Amendment C295case to the Casey Planning Scheme

CASEY FIELDS SOUTH (EMPLOYMENT)
AND DEVON MEADOWS PRECINCT
STRUCTURE PLAN

Casey City Council Submission

Endorsed by Council: 20 May 2025

Figure 1 – Recommended amendments to Concept Drainage Strategy Plan

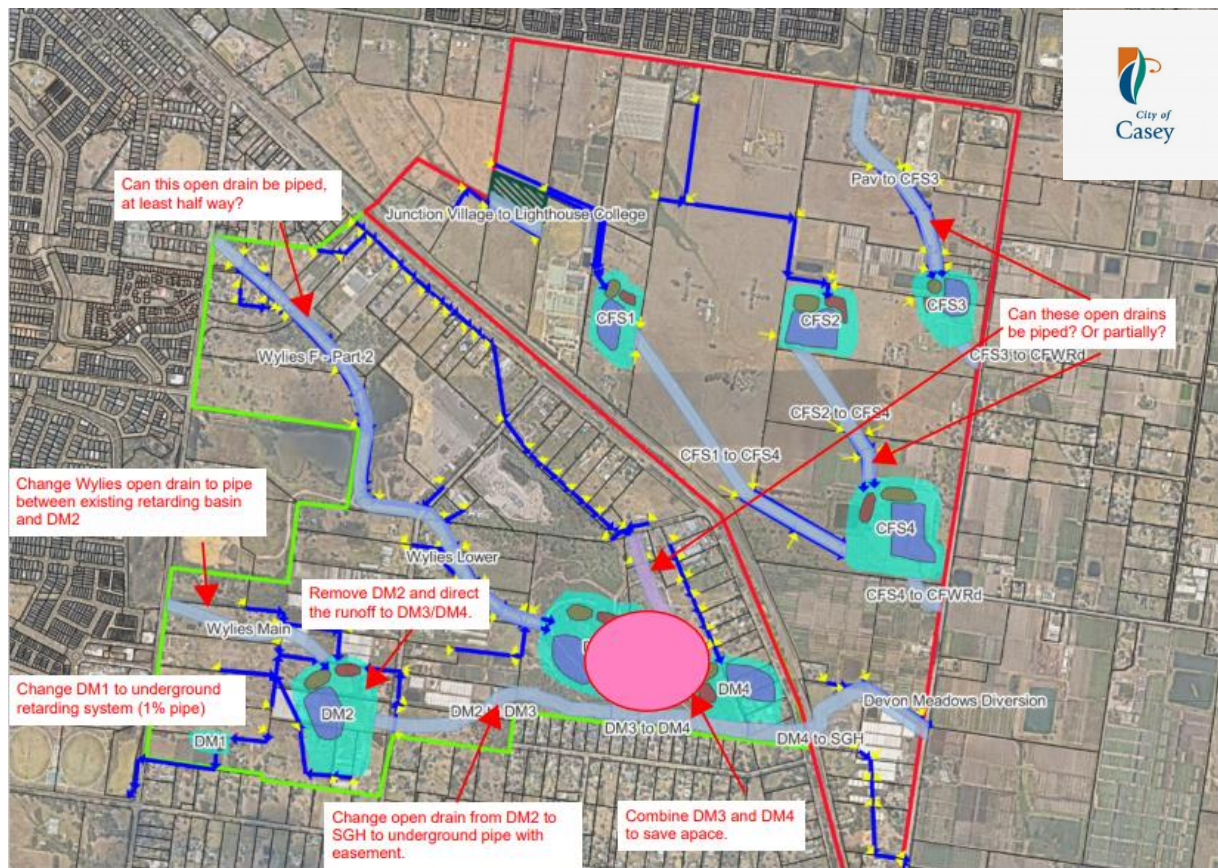
23. Council officers have provided recommended amendments to the Concept Drainage Strategy Plan prepared by GHD to Melbourne Water, which are intended to optimise the waterways and drainage network and reduce constraints on multiple parcels, including:
- (a) increasing the use of piping to replace open drains;
 - (b) remove GHD Ref: DM2 (PSP Plan 6 Ref: DM-RB-04) and direct the runoff to GHD Ref: DM3/DM4 (PSP Ref: DM-RB-02 and DM-RB-03); and
 - (c) combine GHD Ref: DM3 and DM4 (PSP Ref: DM-RB-02 and DM-RB-03) (**Figure 1**).

Figure 4 – Recommended amendments to Staging Plan

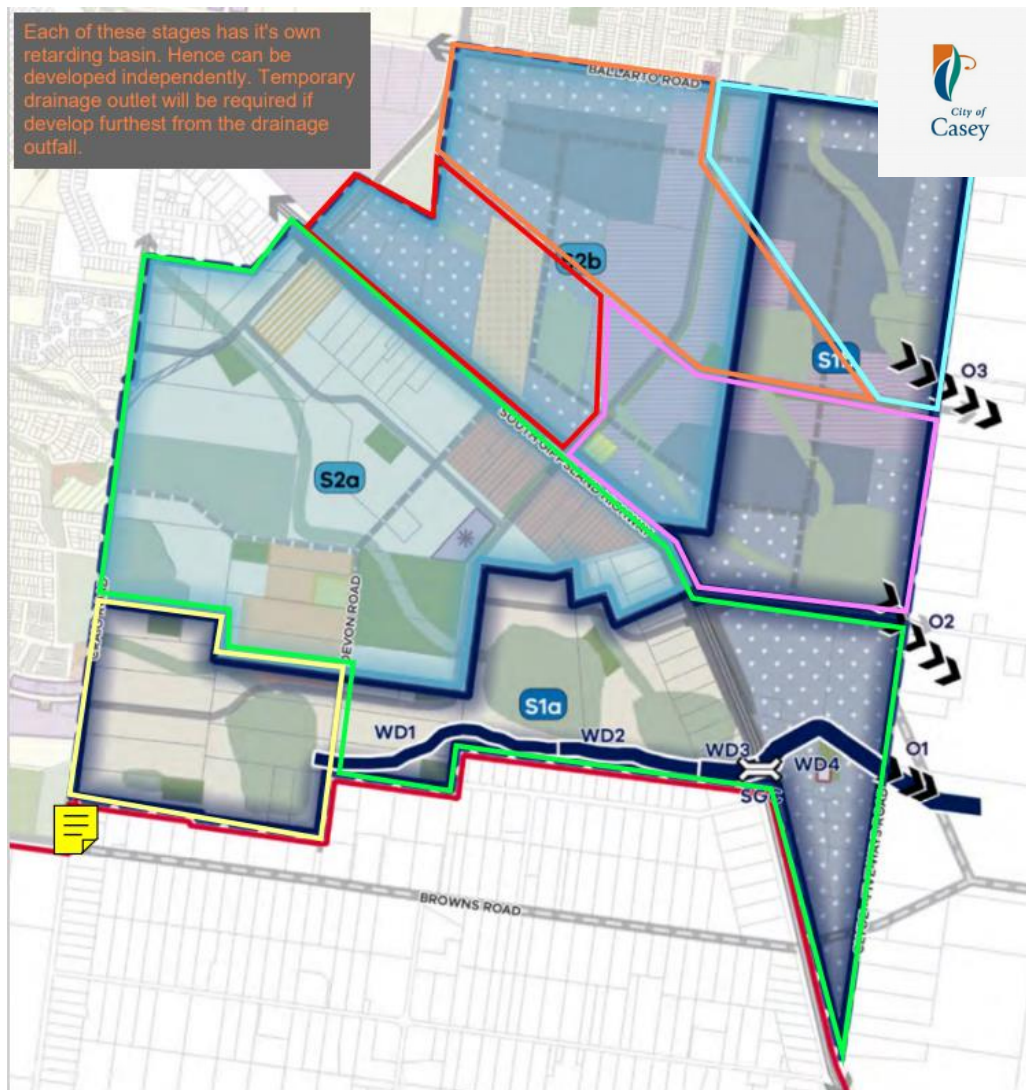
30. Council submits that the staging of infrastructure and development shown on Plan 9 of the draft PSP (**staging plan**) unnecessarily constrains development by:
 - (a) creating large drainage infrastructure stages servicing multiple upstream catchments; and
 - (b) requiring the delivery of multiple ultimate assets within each drainage infrastructure stage before the commencement of development or the issue of a statement of compliance for a plan of subdivision (refer Requirement R27).

31. Council accepts Objective O31 of the draft PSP to ensure development is staged in an orderly manner consistent with the delivery of infrastructure.
32. However, the staging plan must also facilitate not stymie the development of the precinct through onerous requirements for the delivery of multiple ultimate assets.
33. In **Figure 4**, Council water planning officers recommend amendments to the staging plan that remain consistent with Objective O31 but reduce the onerous requirements for the delivery of multiple ultimate assets and, therefore, facilitate development by:
 - (a) increasing the number of stages from four to six;
 - (b) reducing the ultimate assets required to be delivered within each stage; and
 - (c) allowing the independent development of stages.

Figure 6 – Council's optimised open space network

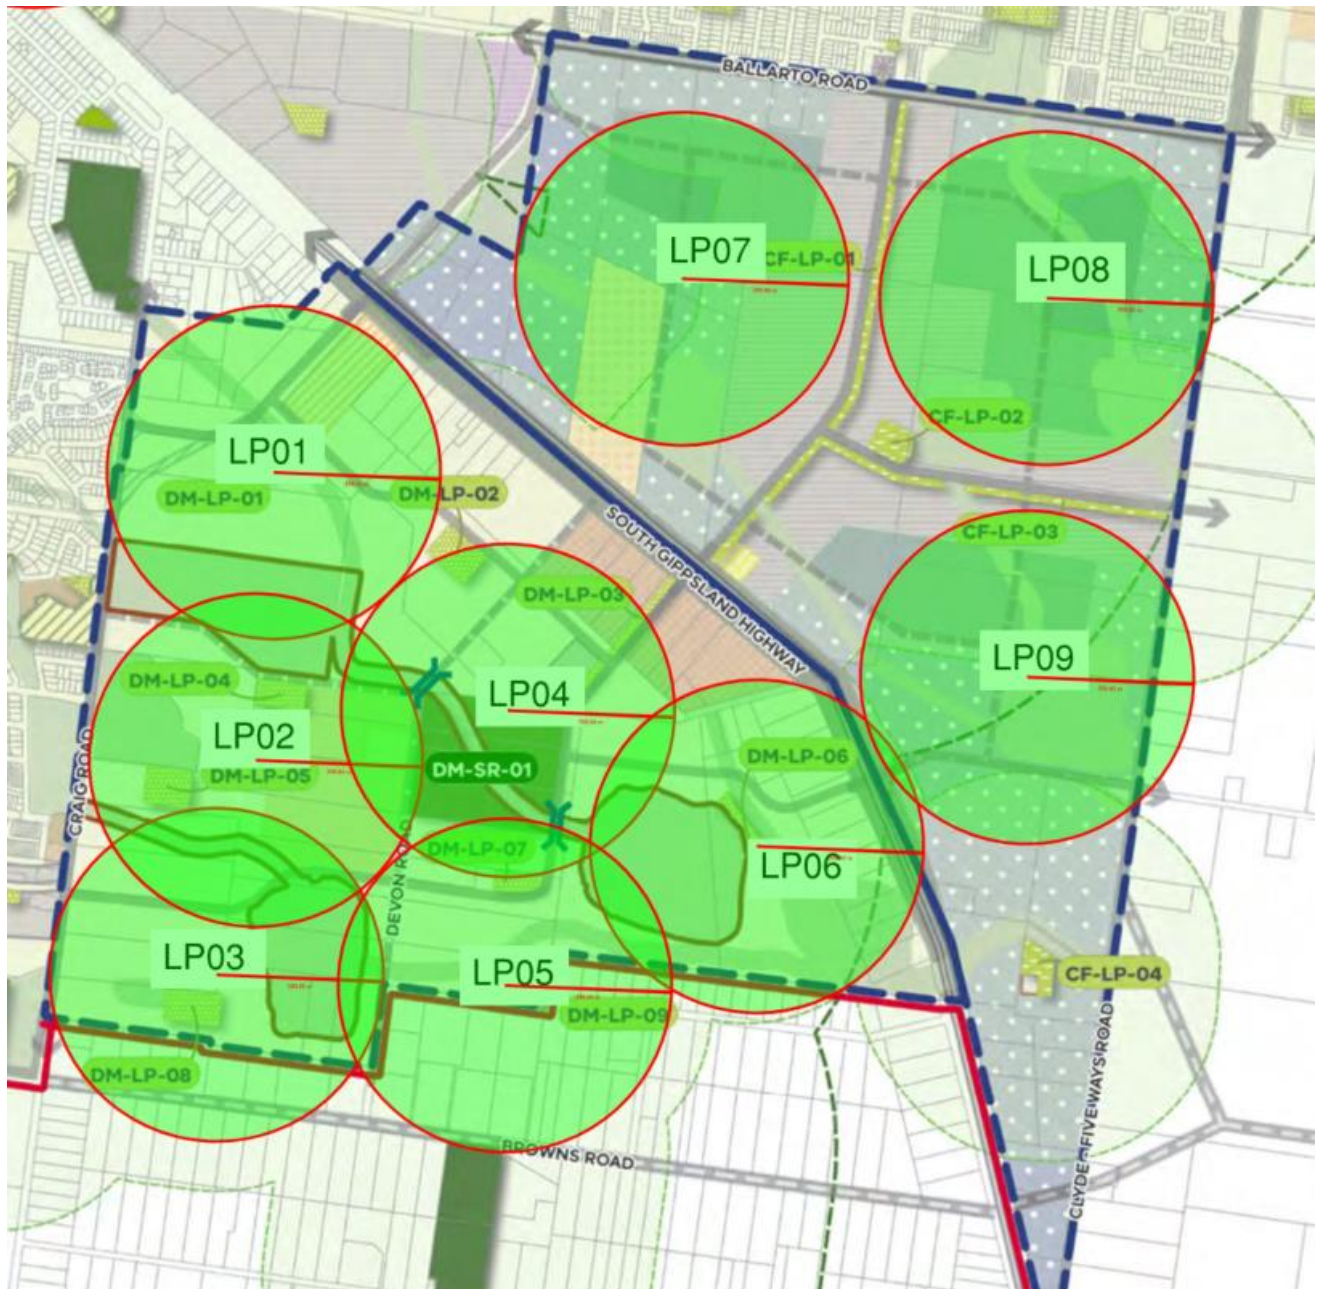
67. **Figure 6** below provides a visual representation of Council's optimised open space network detailed in Table 3, with the red circles indicating a 400m safe walkable distance from each local park.

Figure 7 –South Gippsland Eggs S-Factor Separation Distance in lime green on left panel

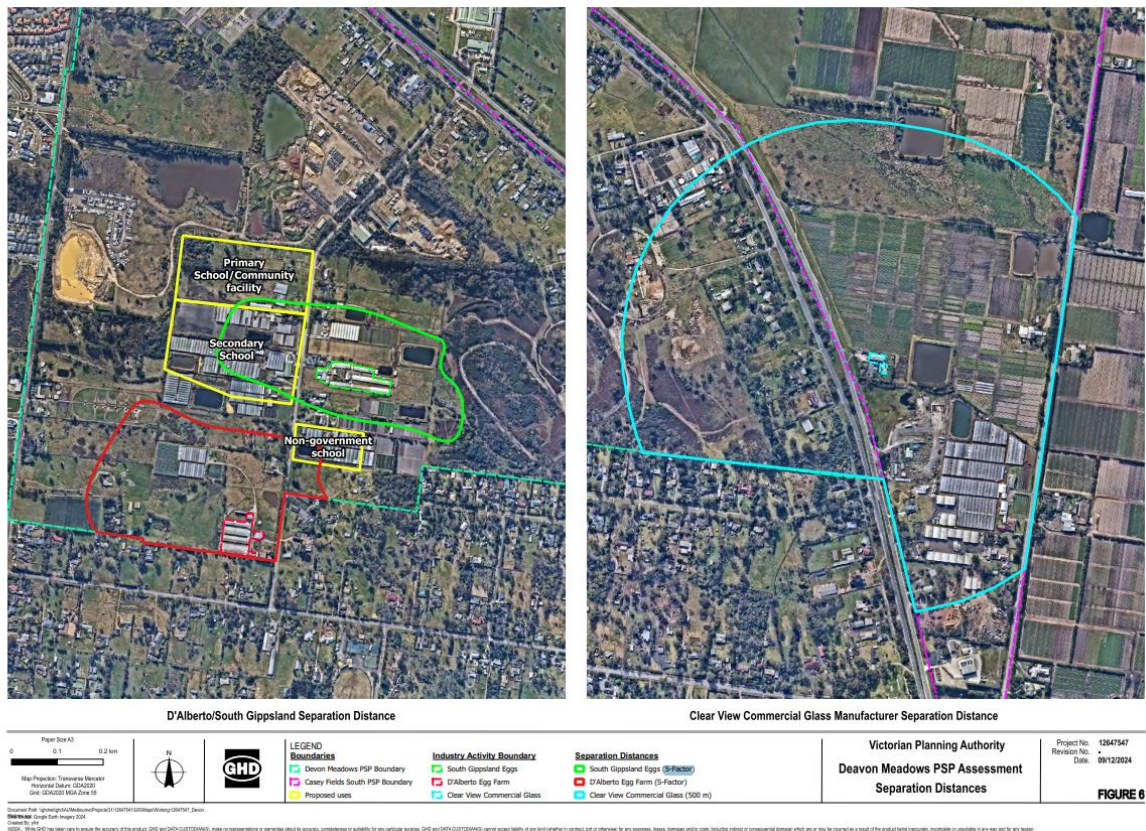
89. Figure 6 of the *Devon Meadows and Casey Fields South (Employment) PSP Odour, Dust, and Noise Assessment* prepared by GHD (**odour, dust and noise assessment**) identifies part of the land for the community facility located within the S-Factor separation distance for the South Gippsland Eggs farm located at 100 Devon Road, Devon Meadows (**Figure 7**).

99. However, Council questions the appropriateness of locating key precinct infrastructure and sensitive uses such as the community facility and government schools within the S-Factor separation distances of the South Gippsland Eggs farm, which raises the prospect of delays in the delivery of this infrastructure until the egg farm ceases operation.

Figure 8 – Required amendments to Plan 2 – Place Based Plan

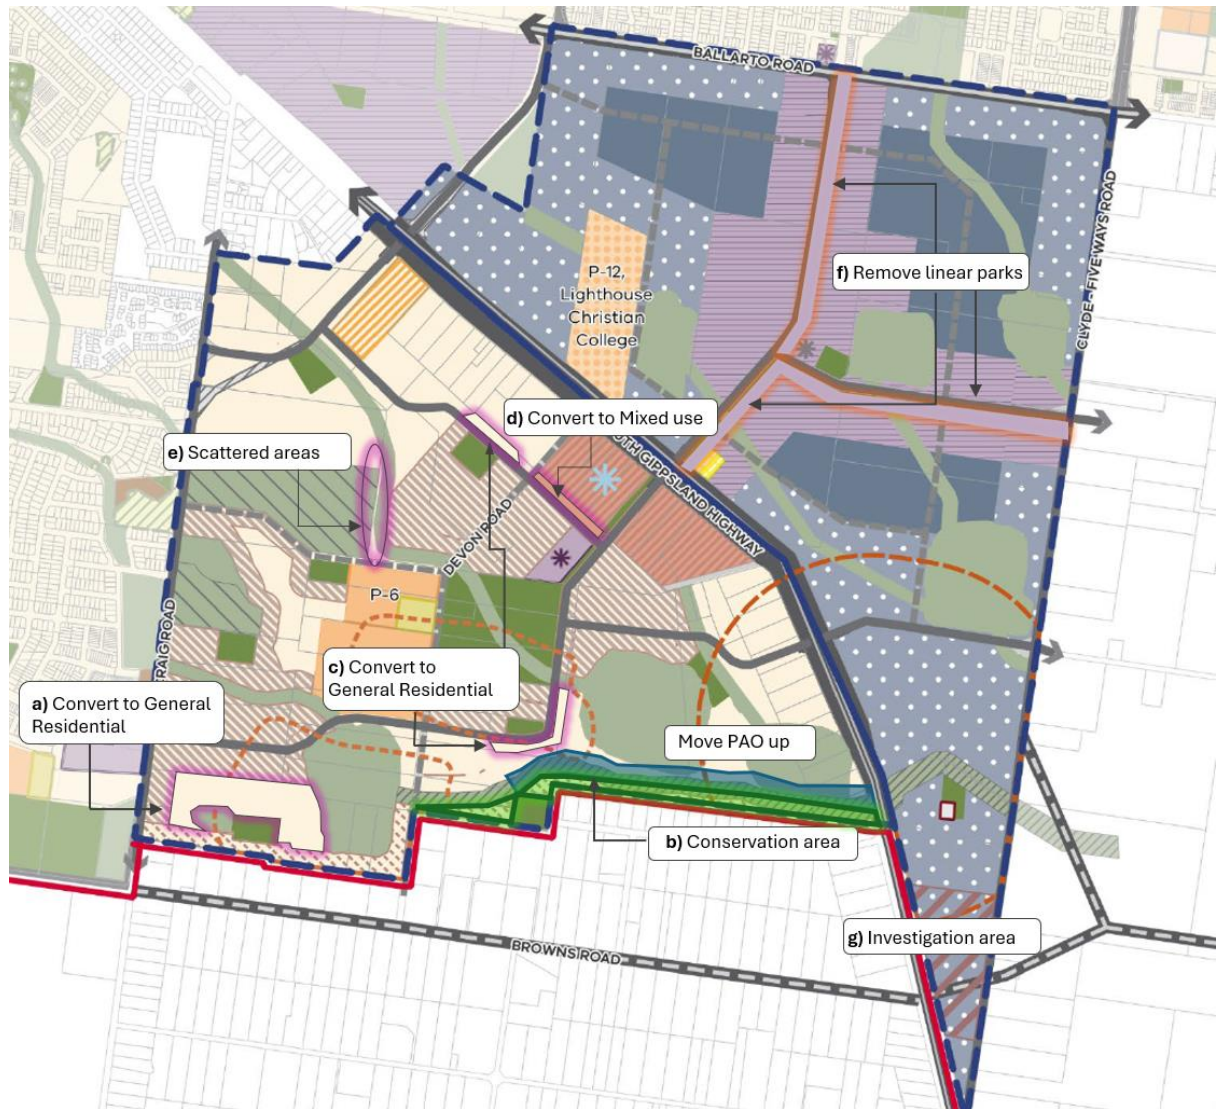
115. Figure 2 of the draft PSP incorporates many urban structure inefficiencies, some of which are marked up in **Figure 8** below and noted in **Supplementary Information Item 1 – Additional Submission Items**.

116. The letter identifiers in Figure 8 above are discussed further below:

- (c) There are indeterminate "areas of increased density" that do not provide a balanced urban structure outcome and must be resolved;
- (d) The expansion of the "mixed use" south-west to the connector street is logical;

- (e) There are many scattered areas of "residential" located between "other uncredited open space" (waterways and drainage) that are undevelopable. Figure 8 provides just one example here. In particular, the irregular shaped waterway and drainage network shown on Parcels DM-49, DM-56, DM-75, DM-78, DM-81 and DM-82 are likely to render significant parts of these parcels undevelopable. Council is concerned with this proposal, noting that the viable development of these parcels is critical to the provision of the enabling drainage infrastructure required to catalyse the development of the wider precinct (Plan 9);

119. In item (b) on Figure 8 above, Council proposes a conservation area that protects native vegetation located on the southern boundary of Devon Meadows and the Urban Growth Boundary.
